April 4, 2014  
ES/NRC 14-006  
Docket No. 72-1007

**Subject: Response to Request for Additional Information for the VSC-24 CoC  
Renewal Application (TAC No. L24694)**

### Summary of Changes, Certificate of Compliance Renewal Application for the VSC-24 Ventilated Cask Storage System, Revision 2

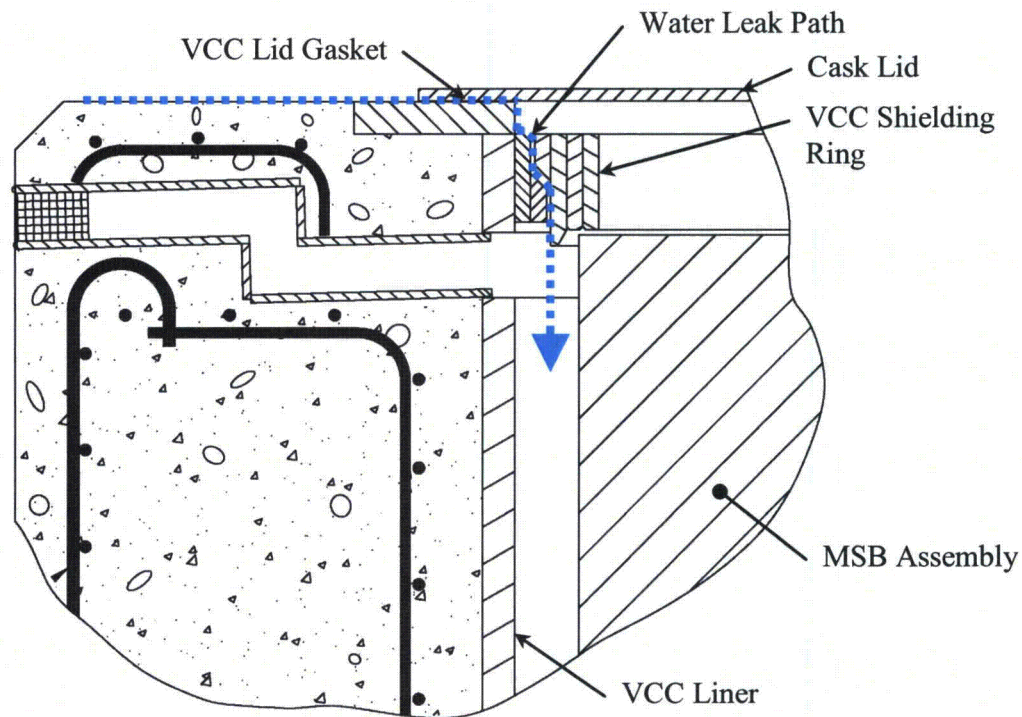
*RAI-3. Provide a TLAA for the polymeric gaskets used for the weather covering and explain how the TLAA will be verified through inspections and justify the frequency of inspections. Alternatively, justify that failure of the polymeric gaskets will not lead to accelerated corrosion of the VSC-24 exteriors.*

*Polymeric materials, even if not in the presence of a radiation field, will embrittle, creep, and degrade over time. The staff finds that polymeric gasket materials may not function as intended over a 60-year lifespan. The integrity of the weather cover establishes the conditions for the aging management of the system and thus needs a TLAA.*

The VCC lid gasket lies in a sheltered environment with very low radiation levels. Only the inside and outside edges of the VCC lid gasket are directly exposed to an oxidizing atmosphere. Therefore, minimal degradation of the VCC lid gasket is expected to occur during the extended storage period. Unless the VCC lid gasket is disturbed, it is not expected that the lid gasket will allow any water to leak into the VCC cavity. The most likely disturbance of the cask lid is if the bolts and lid are removed, but as discussed in the response to RAI-20, the old lid gasket is required to be replaced with a new lid gasket the prior to re-installation of the cask lid, regardless of condition of the old lid gasket. Therefore it is highly unlikely for the lid gasket to degrade and leak. Nonetheless, in the unlikely event that degradation of the VCC lid gasket material results in a water leak, the design of the VCC shielding ring plates will direct water flow down the VCC annulus and prevent water from accumulating on the top of the MSB assembly, thereby preventing the possibility of accelerated corrosion of the MSB structural lid and closure weld.

The VCC shielding ring is placed on the top of the cask liner assembly after the MSB assembly is lowered into the VCC cavity. It fits loosely inside the cask support rings at the top of the cask liner and extends over the top corner of the MSB assembly. As shown in the figure below, any water that leaks through the VCC lid gasket will be directed down the annular gap between the cask liner and VCC shielding ring, where it will drip to the bottom of the VCC annulus, and will not collect on the MSB structural lid, thereby preventing accelerated corrosion of the MSB lid or welds. Any significant amount of water that drips to the bottom of the VCC annulus will drain out the VCC inlet channels. The carbon steel surfaces of the VCC liner and MSB assembly that form the VCC annulus are coated for corrosion protection. Moisture that accumulates on the coated surfaces of the VCC liner and MSB shell will evaporate or drain out of the VCC assembly. Therefore, failure of the VCC lid gasket is not expected to lead to accelerated corrosion of the VCC liner and MSB shell.

**Condition of Palisades Lead Cask VCC Lid Bolts**

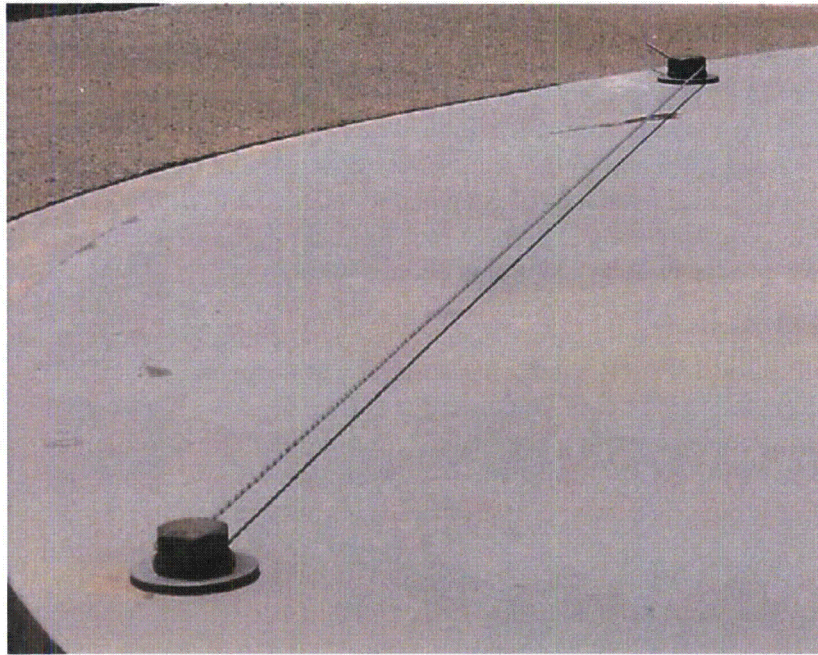
*RAI-9. Provide a corrosion analysis with the predicted corrosion rate for the VCC bolts over the 40-year renewal period. Explain how the predicted corrosion rate is determined and verified through inspections and justify the frequency of inspections.*

The VCC lid bolts are made from A307 carbon steel with a zinc coating or other protective finish. The protective finish on the VCC lid bolts is intended to inhibit corrosion. However, the VCC lid bolts may experience some corrosion during the extended storage period, as operating experience shows. As noted in the Palisades Lead Cask Inspection Report, when the VCC lid bolts were removed, some corrosion was identified on the bolts. However, as shown in the picture below, the amount of corrosion on the VCC lid bolts of the Palisades lead cask was limited to local discoloration of the surface finish, and as such, they were determined to be acceptable for continued use.

Potential aging effects in the VCC lid bolts are managed by AMP, not TLAA. The AMP requirements for managing aging effects in the VCC lid bolts are discussed in the response to RAI-20.

**Photographic Evidence of No Crevice Corrosion at MSB Top Corner**

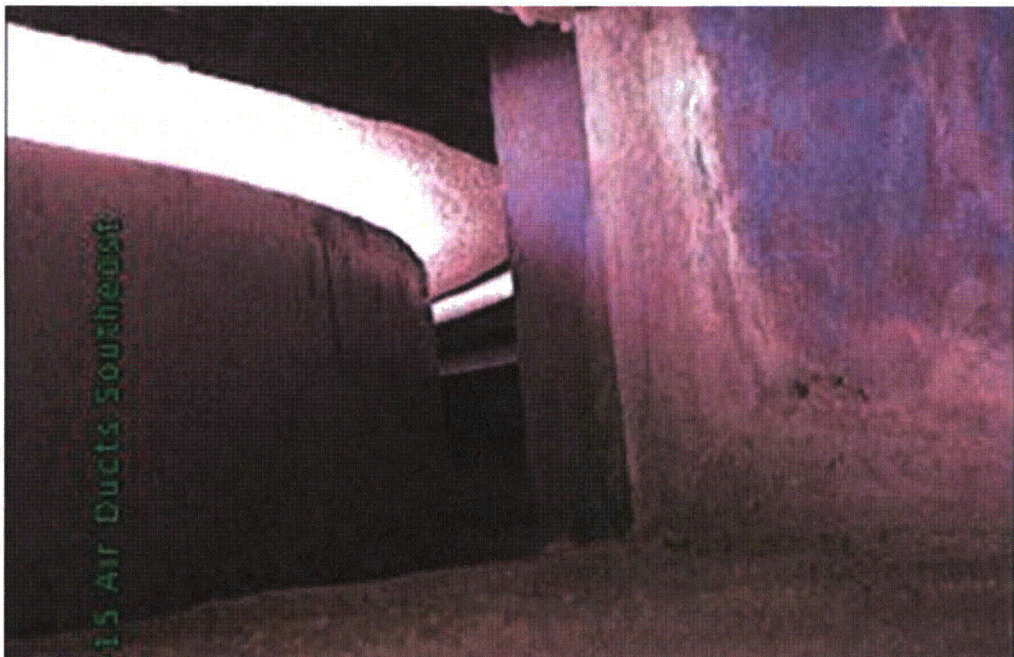
*This information is required to demonstrate compliance with 10 CFR 72.11.*

As discussed in Section 3.2.2.4, the VCC shield ring was lifted by a small amount (approximately 3-inches) to allow visual inspection of the MSB top corner region (i.e., the MSB closure weld), as shown in the first figure below. The visual examination did not identify any evidence of crevice corrosion occurring between the top end of the MSB assembly and the VCC shield ring. Further evidence of the lack of crevice corrosion at the top end of the MSB assembly is shown in the photographs provided below, which are included in the Palisades Lead Cask Inspection Report. The first photograph shows the top edge of the MSB shell exposed after lifting the shield ring. There are no visible signs of corrosion on the top corner of the MSB shell, although some coating was inadvertently scraped off, as discussed in Section 3.4.4 of the renewal application. The second photograph, which is taken from inside one of the VCC air outlet assemblies looking at the top corner of the MSB assembly, shows some discoloration of the coating at the top end of the MSB shell due to high temperatures experienced during the closure welding process, but no signs of corrosion.
